Dammon Engineering, Inc.

RE: P0389436
MARCO'S PIZZA SELA#1 SUITE 1
2349 EAST GAUSE BLVD
SUITE 1
SLIDELL, LA 70469

EXISTING
1HR FIRE
RATED
WALL.

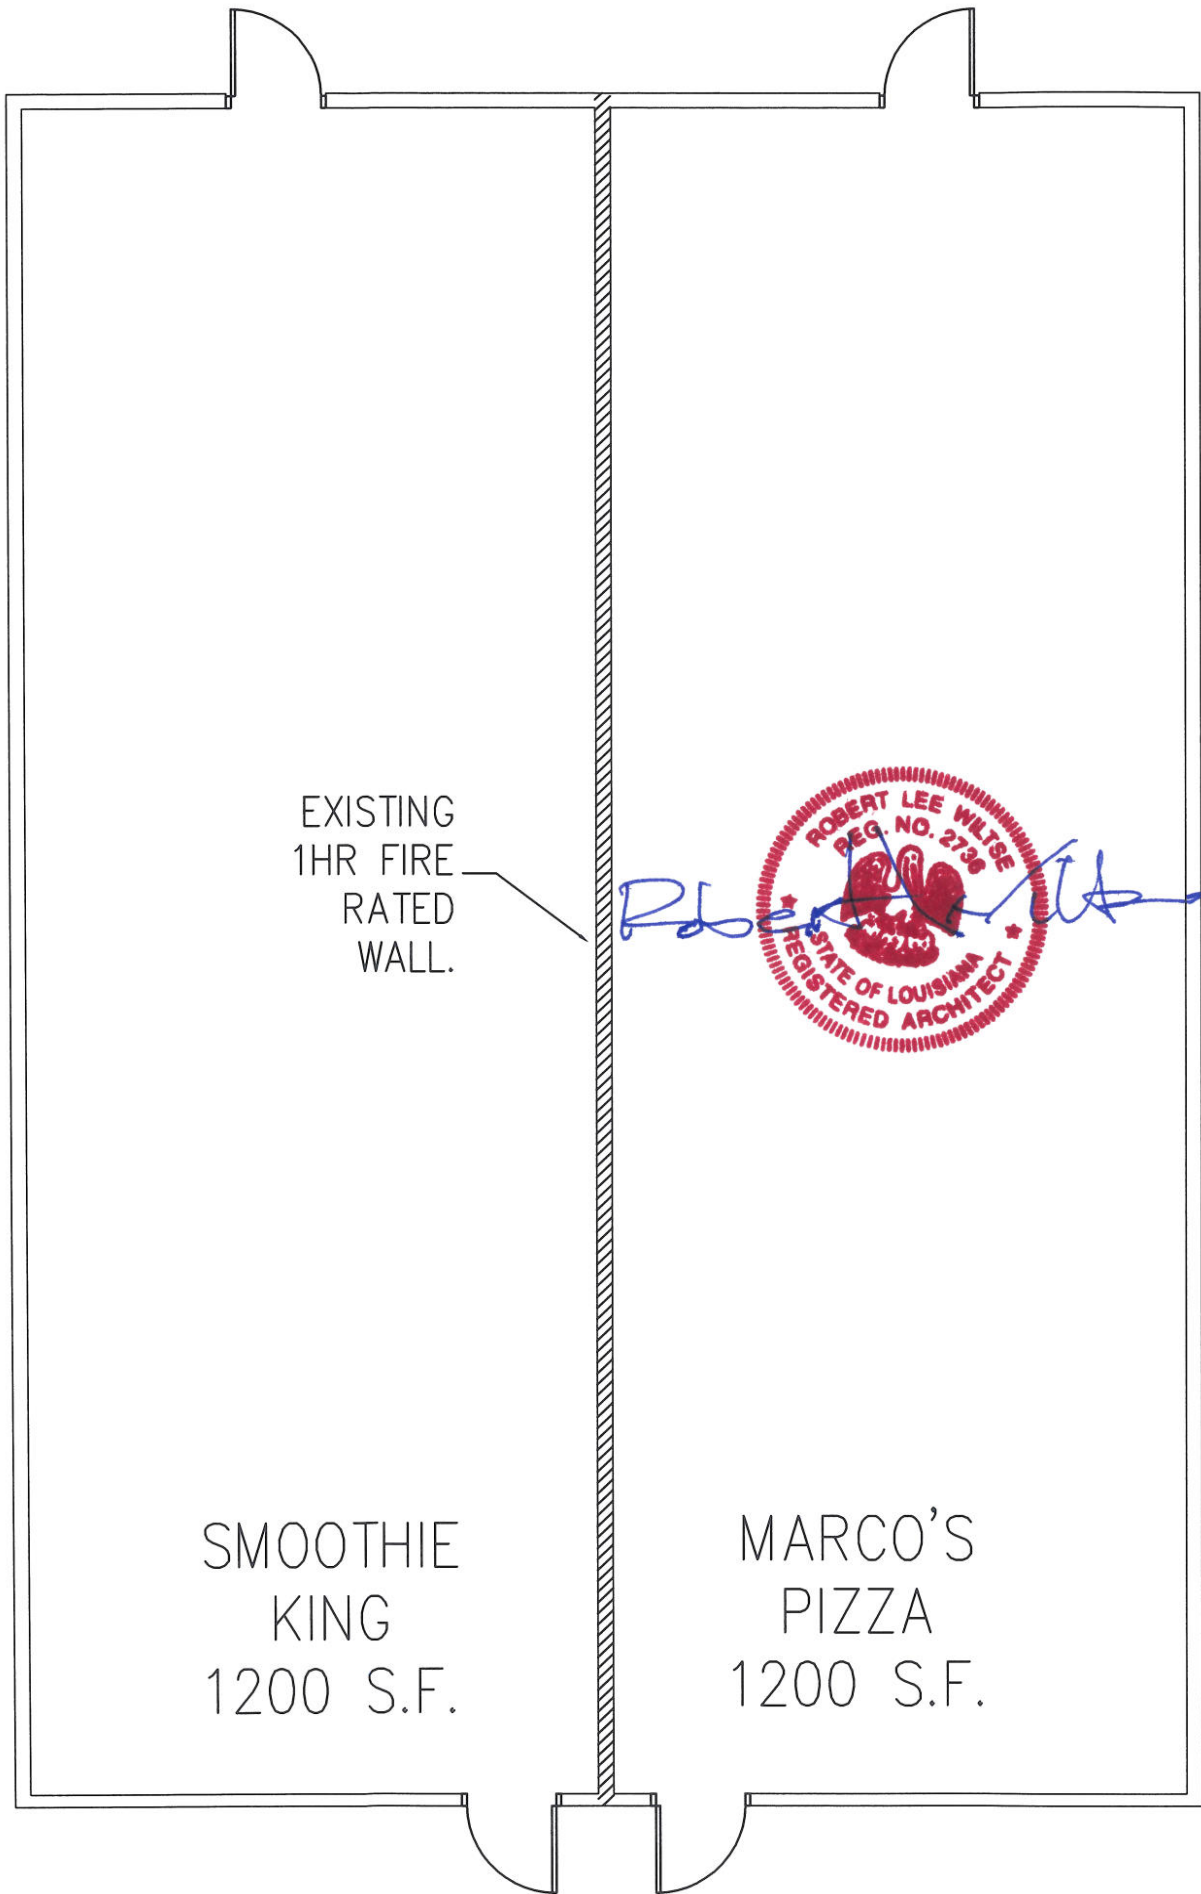
With regard to the above referenced project, the existing demising wall between Suite 1 and Suite 2 was incorrectly labeled on our construction drawings. The construction drawings showed this existing demising wall as an existing 2-hr rated wall. This wall should have been labeled as existing 1-hr. rated wall. Please see attached drawing.

The current tenant in Suite #2 is a Smoothie King restaurant, also the owner of the building; Smoothie King has the same square footage as the new Marco's Pizza, 1200 s.f. Both Smoothie King and Marco's Pizza would be the same occupancy, Assembly under 50 occupants - Mercantile. According to NFPA 101, table 6.1.14.4.1(b), there is no separation required between the same occupancies. Therefore a 1-hr. rated wall complies with the NFPA 101.

Instructions have been provided to the contractor to maintain the existing 1-hr fire rating.
